Site: Units 2 &3, Botley Road, Fair Oak

Subject: Eastleigh Borough Council Planning Ref: F/22/94393
Proposed Change of Use from Betting Shop to Hot Food Takeaway

Title: Response to Pollution Control Team Comments

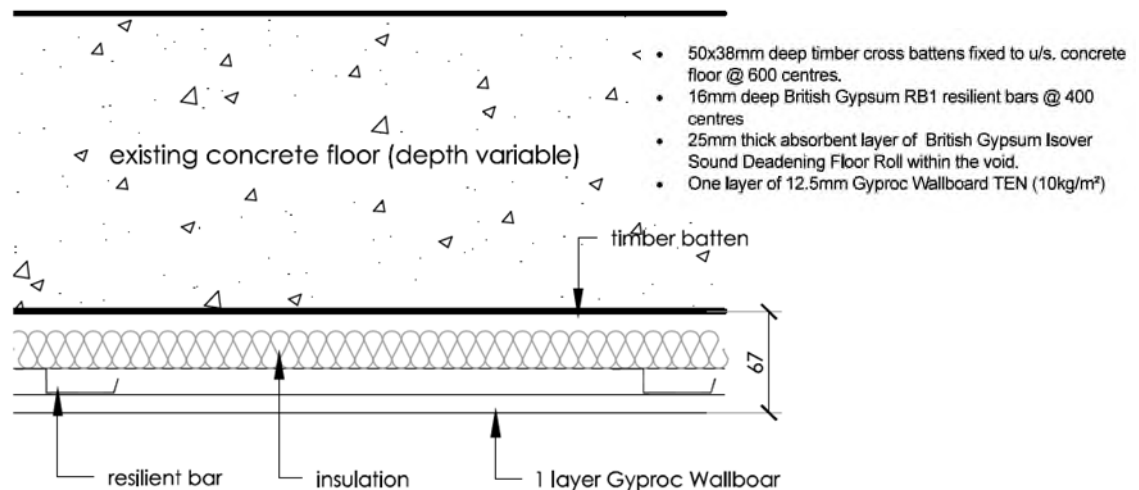
- (2) *Can the ceiling and floor provide adequate sound insulation to prevent audible premises noise transmitting into the dwellings above?*
 - (3) *Noted the assessment says there will only be car deliveries. How can the premises prevent the use of motorcycles ? It seems this is not possible (nor reasonably enforceable) , whereas motorcycle noise is more likely to disturb dwelling occupants and motorcycles as commonly associated with meal collection and delivery.*

- 1.24 Notwithstanding the above, we can also clarify that the fit-out proposals for the proposed unit will remove the existing lay-in grid ceiling within the unit and replace this and an additional plasterboard ceiling underdrawn below the existing structure with quilt to the cavity as per detail overleaf.

- 1.25 This construction will then be underdrawn with a further suspended mineral fibre type ceiling.
- 1.26 These proposals should therefore further optimise the sound insulation of the separating structure and sound transference.
